West Winch Housing Access Road Detention Basin Survey Update Technical Note

Document Reference: ncc/3.11.01N

Version Number: P01

Date: February 2024

Figure 1 - Basin 1 design based on LiDAR

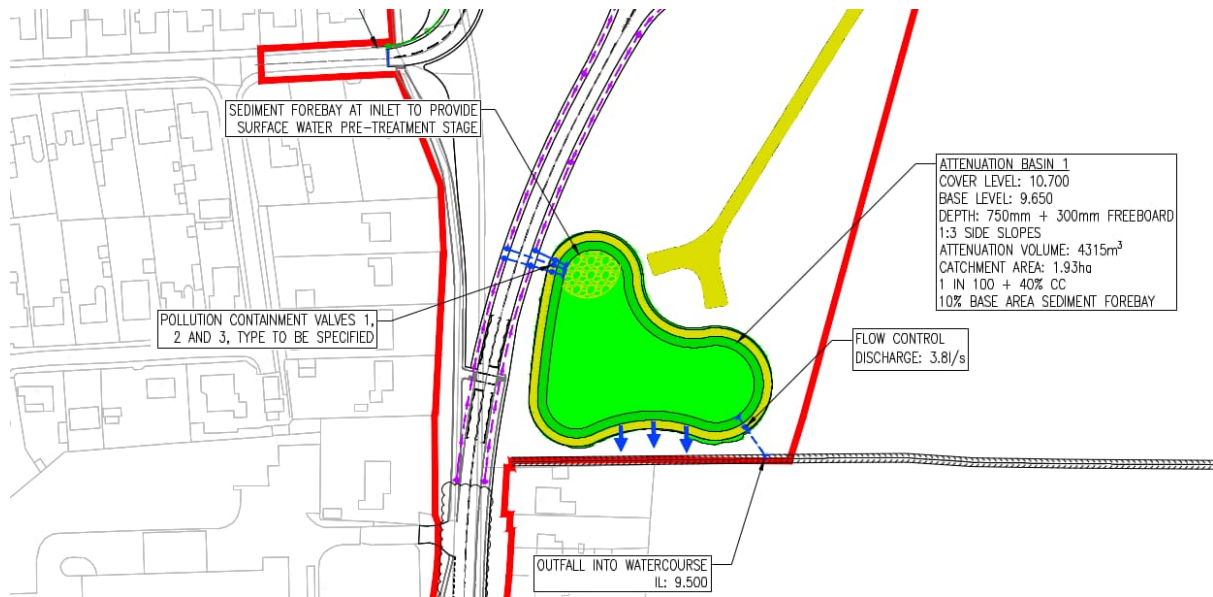
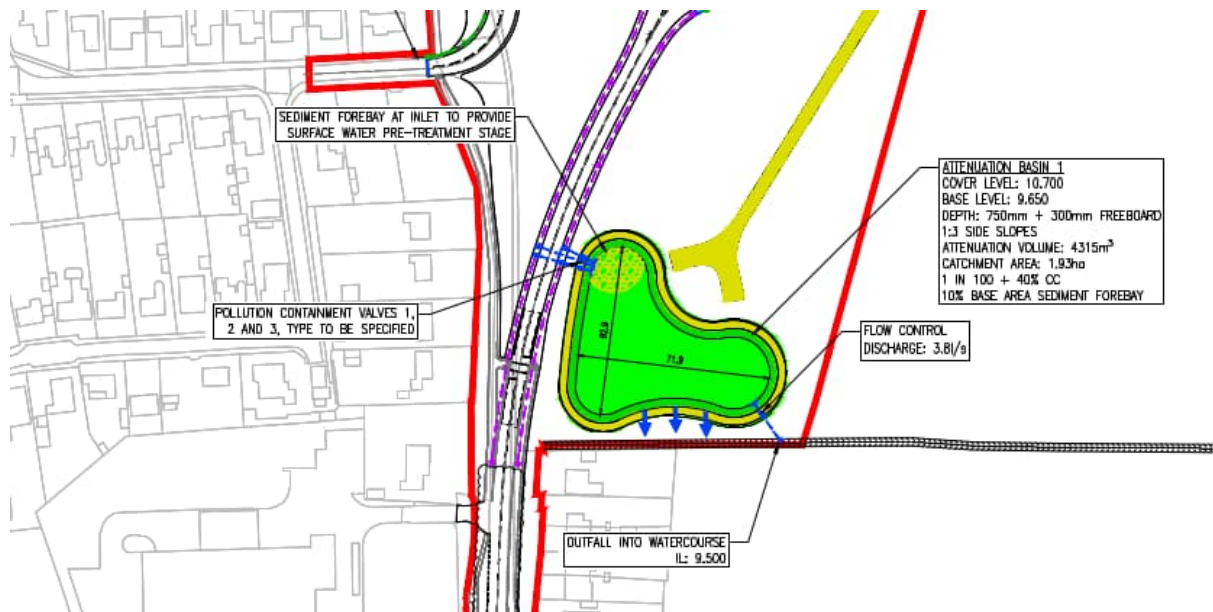
3.2.1 For basin 1 comparison shows that the level differences between the LiDAR and Topographical Survey are typically less than +/- 50mm. The small level differences measured do not have a big impact on the design of the basin.

3.2.2 Due to the similarity in levels, both the cover levels and invert levels have remained unchanged. The only modification made is to the earthworks extents required to tie into existing levels, which have experienced a slight decrease (10%) in area from approximately 115m² to 103m². The change in extents shown does not detriment the drainage strategy nor other design aspects of the proposed Access Road.

Figure 3 - Basin 2 design based on LiDAR

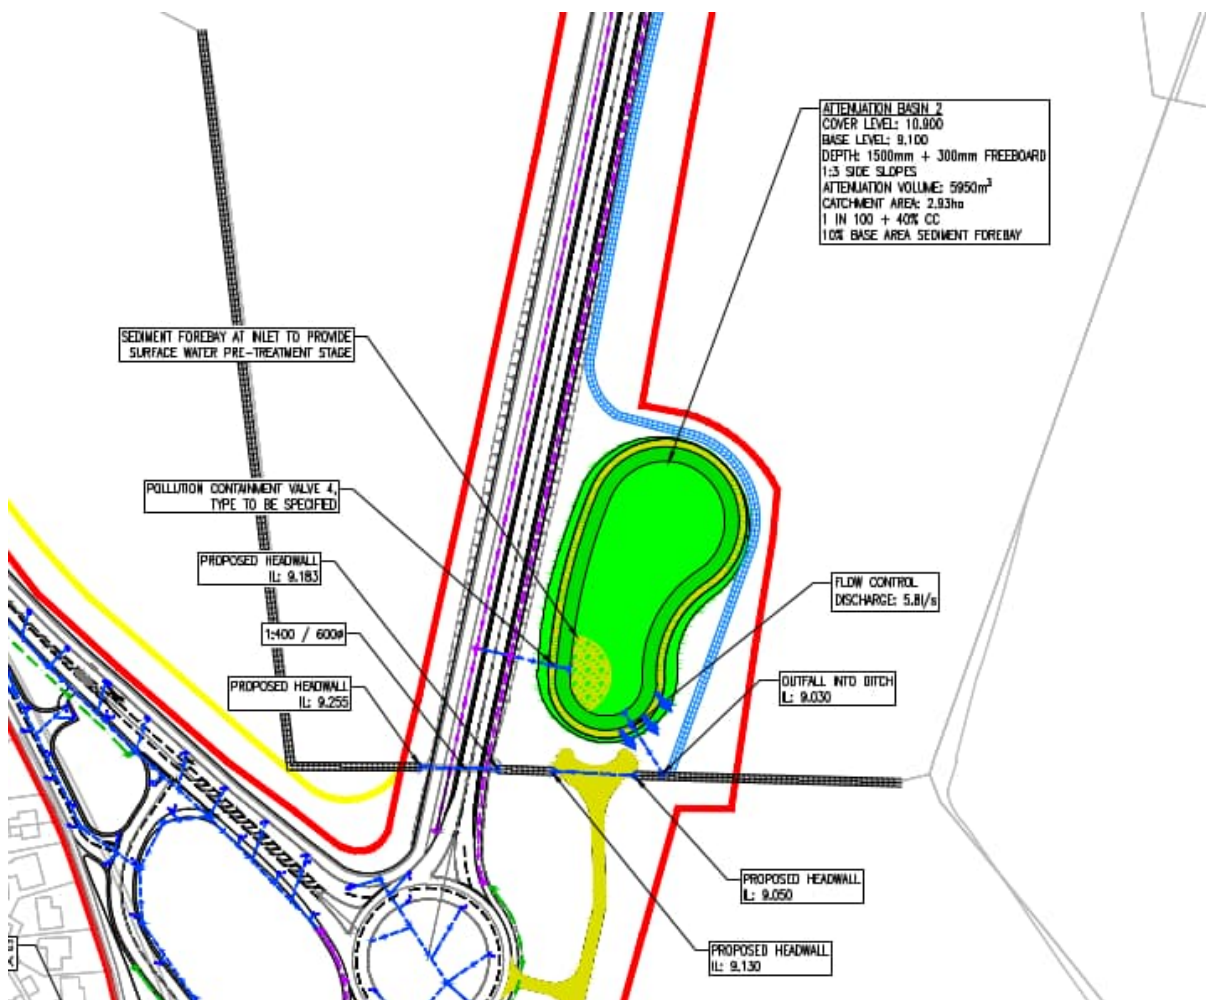
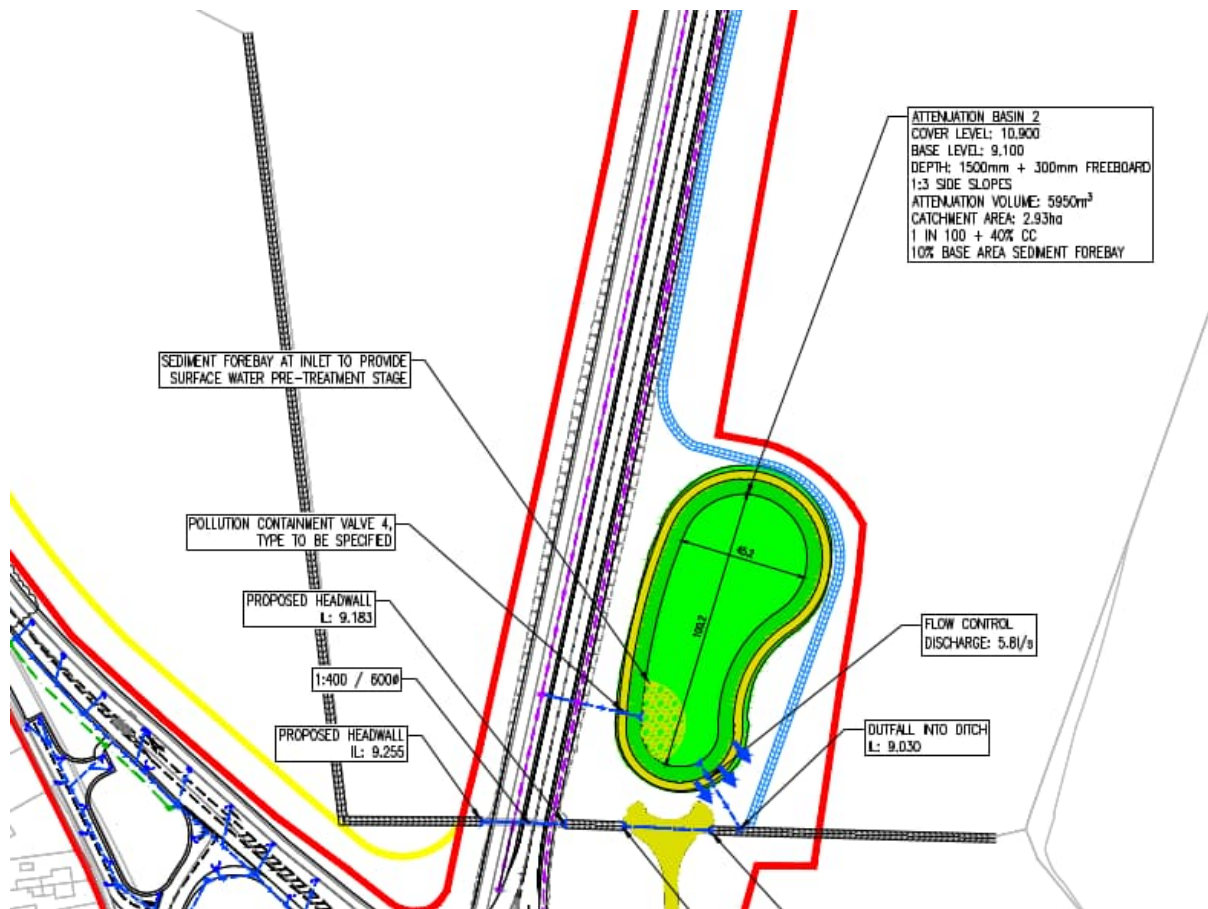
3.3.1 As with basin 1, the difference in levels in basin 2 are typically less than +/- 50mm, with one localised area where level differences are between 100mm and 300mm. The small level differences measured have not impacted the drainage strategy, with measured levels within 50mm of design levels for most of the basin area.

3.3.2 Due to the similarity in levels, both the cover levels and invert levels have remained unchanged. The only modification made is to the earthworks extents required to tie into existing levels, which has experienced an increase (3%) in area from 287m² to 296m². The change in extents shown does not detriment the drainage strategy nor other design aspects of the proposed Access Road.

Figure 5 - Basin 3 design based on LiDAR

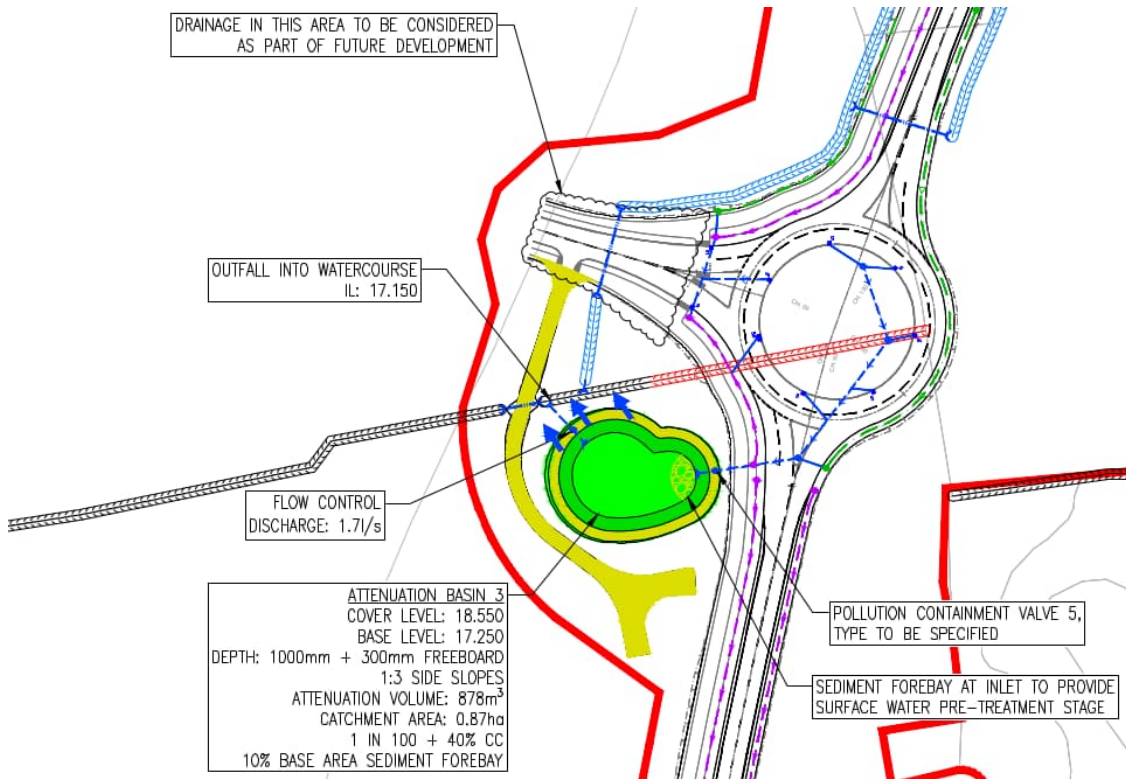
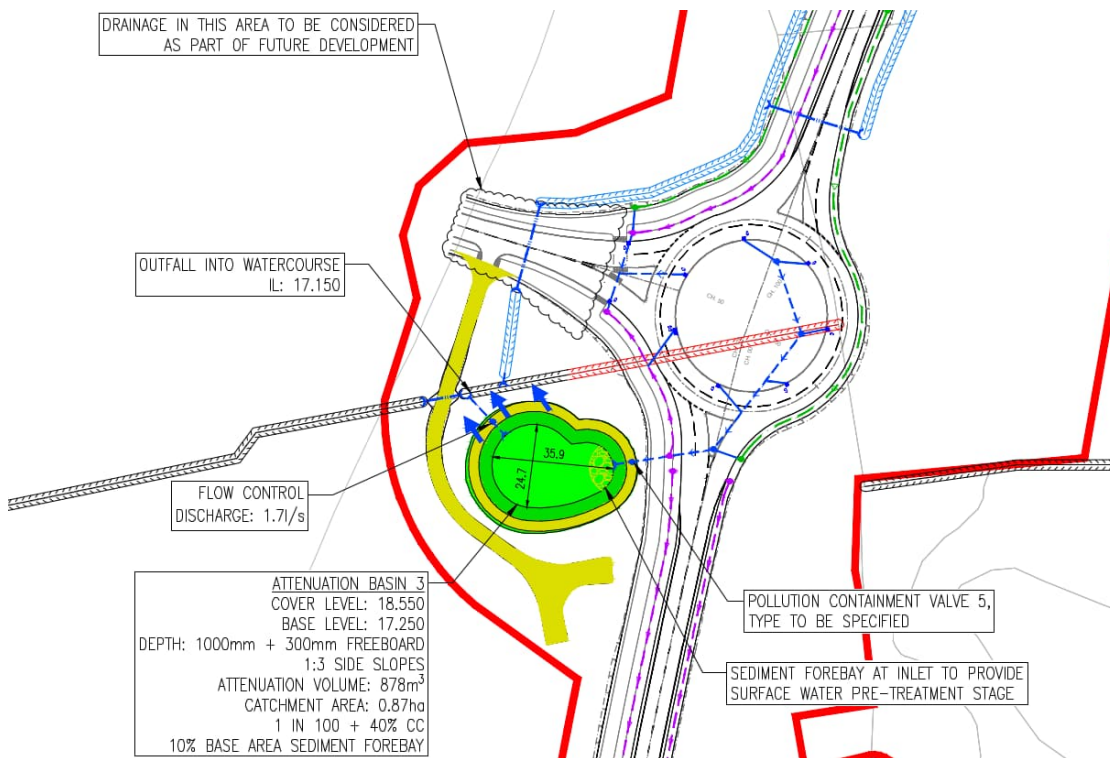
- 3.4.1 Level differences in this area are typically +/-50mm with some localised areas of differences up to 100mm. The small level differences measured have not impacted the drainage strategy, with measured levels within 50mm of design levels for most of the basin area.
- 3.4.2 Due to the similarity in levels, both the cover levels and invert levels have remained unchanged. The only modification made is to the earthworks area, which whilst the extents have changed – the overall area has remained consistent at 58m². The change in extents shown does not detriment the drainage strategy nor other design aspects of the proposed Access Road.

Figure 7 - Basin 4 design based on LiDAR

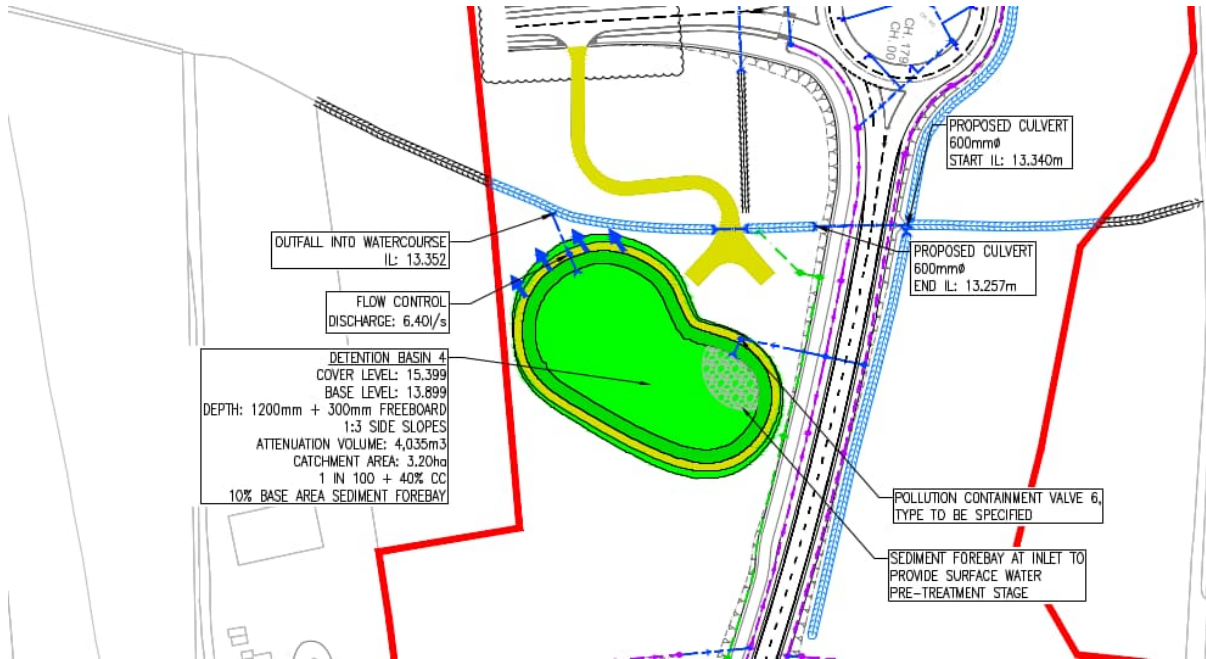
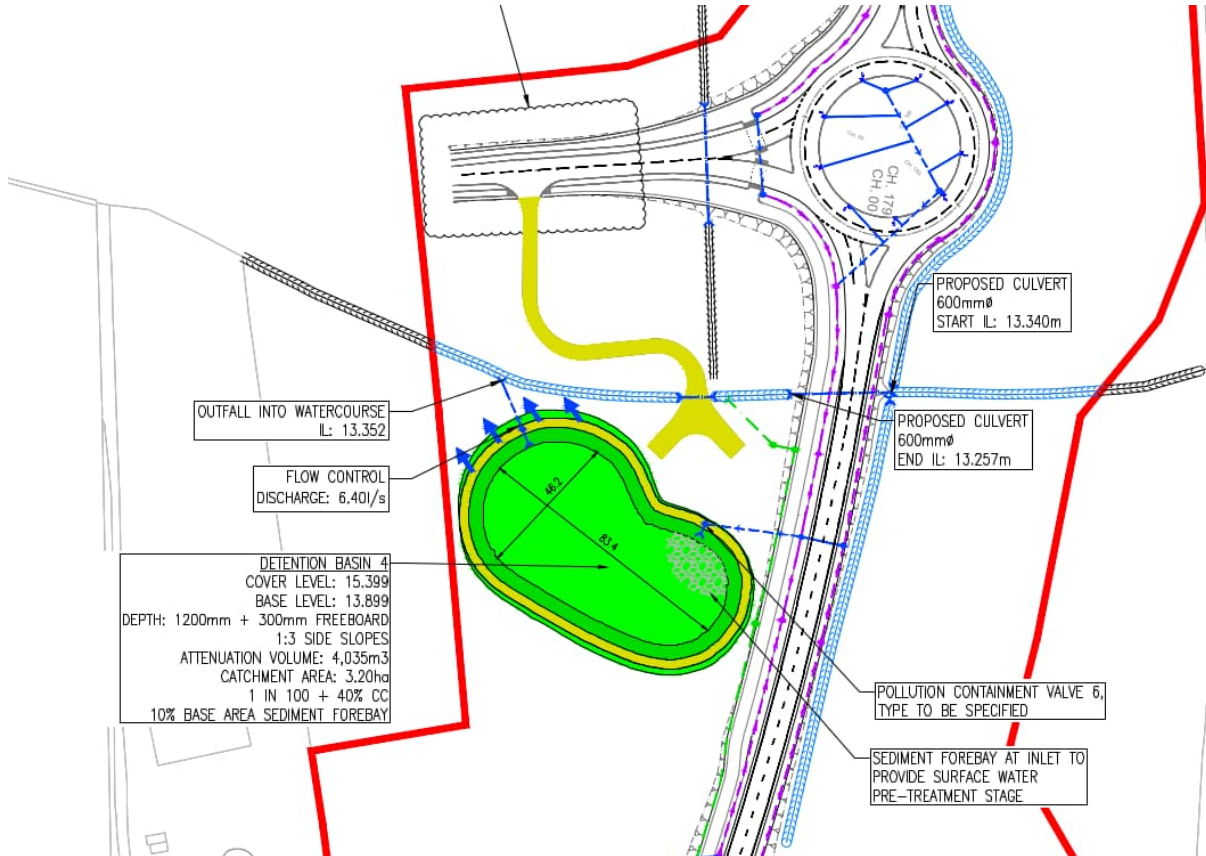
- 3.5.1 For the area available, differences are predominantly +/-50mm with a band of slighter higher differences up to 100m across the centre. The small level differences measured have not impacted the drainage strategy, with measured levels within 50mm of design levels for most of the basin area.
- 3.5.2 Due to the similarity in levels, both the cover levels and invert levels have remained unchanged. The outfall levels were initially determined based on a topographic survey. The only modification made is to the earthworks extents required to tie into existing levels, which have experienced a slight decrease (5%) in area from approximately 411m² to 394m². The change in extents shown does not detriment the drainage strategy nor other design aspects of the proposed Access Road.

Figure 9 - Basin 5 design based on LiDAR

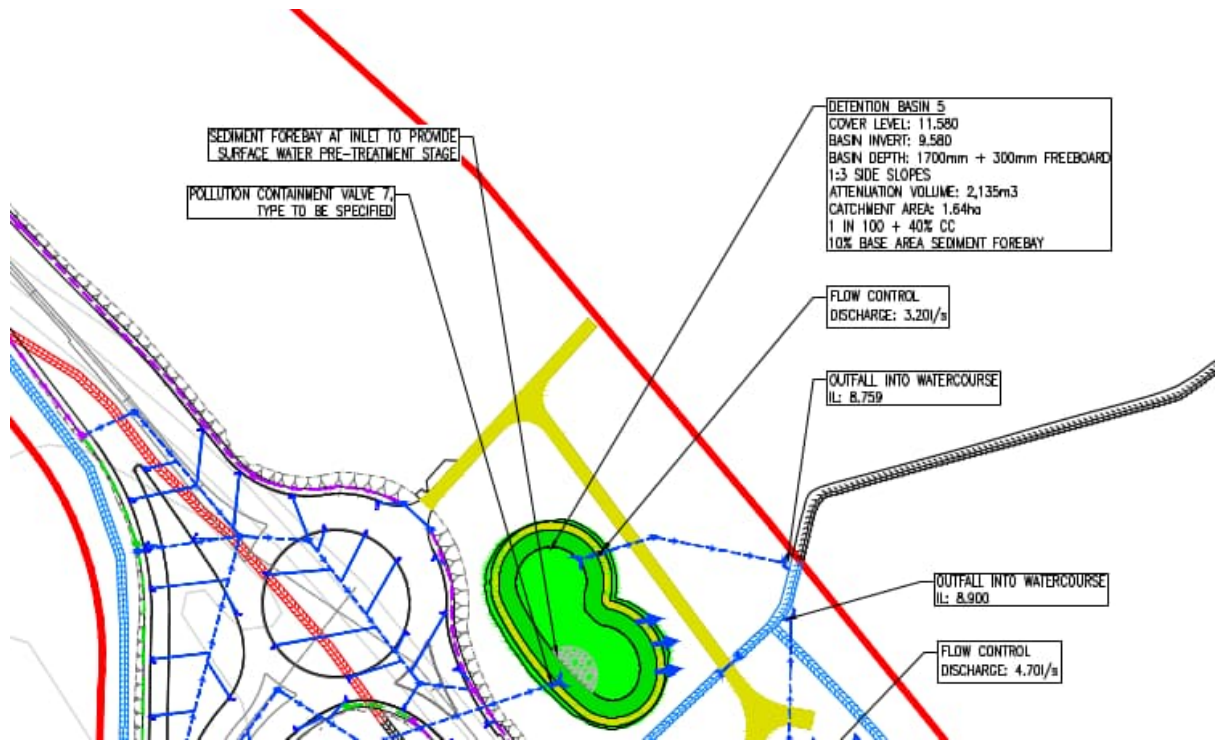
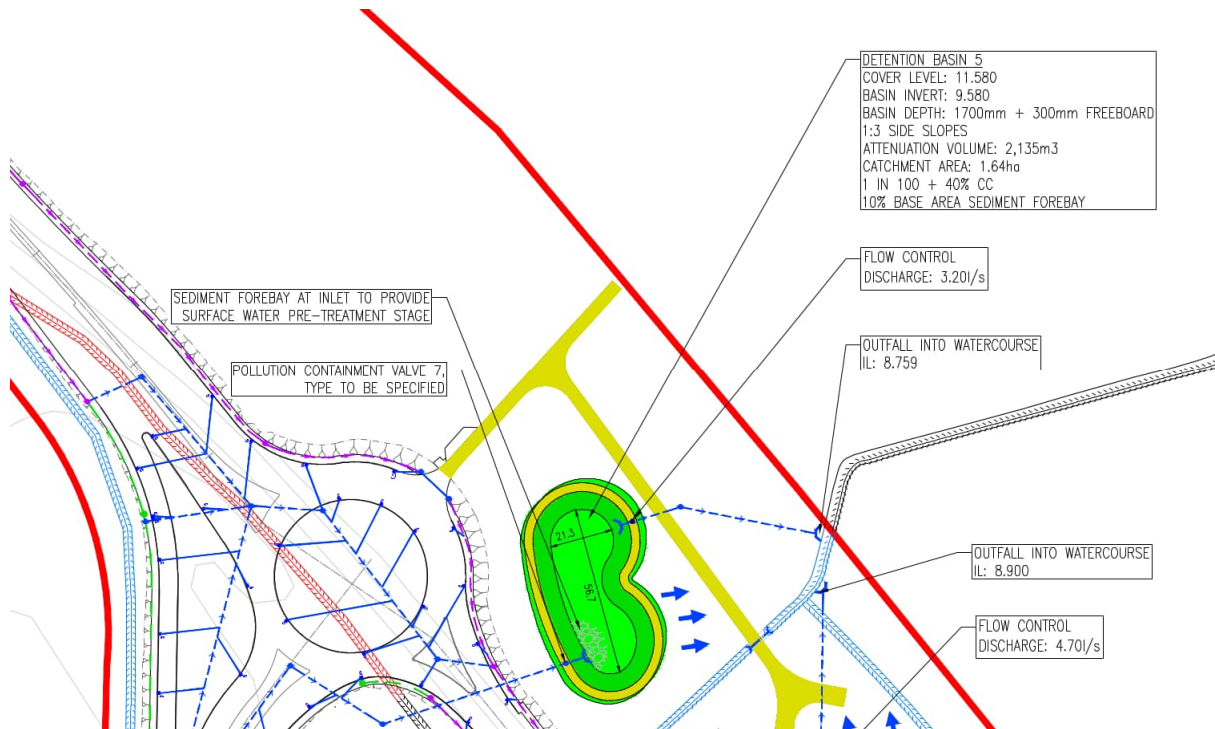
- 3.6.1 For basin 6, differences between the two surveys are differences predominantly between 50 and 100mm with some areas in the southern part of the basin between 100 and 300mm.
- 3.6.2 Due to the similarity in levels across the area of the basin and in order to preserve the required attenuation volumes, both the cover levels and invert levels have remained unchanged. The outfall levels were initially determined based on a topographic survey. The only modification made is to the earthworks extents required to tie into existing levels, which have experienced a slight decrease (4%) in area from approximately 273m² to 262m². The change in extents shown does not detriment the drainage strategy nor other design aspects of the proposed Access Road.
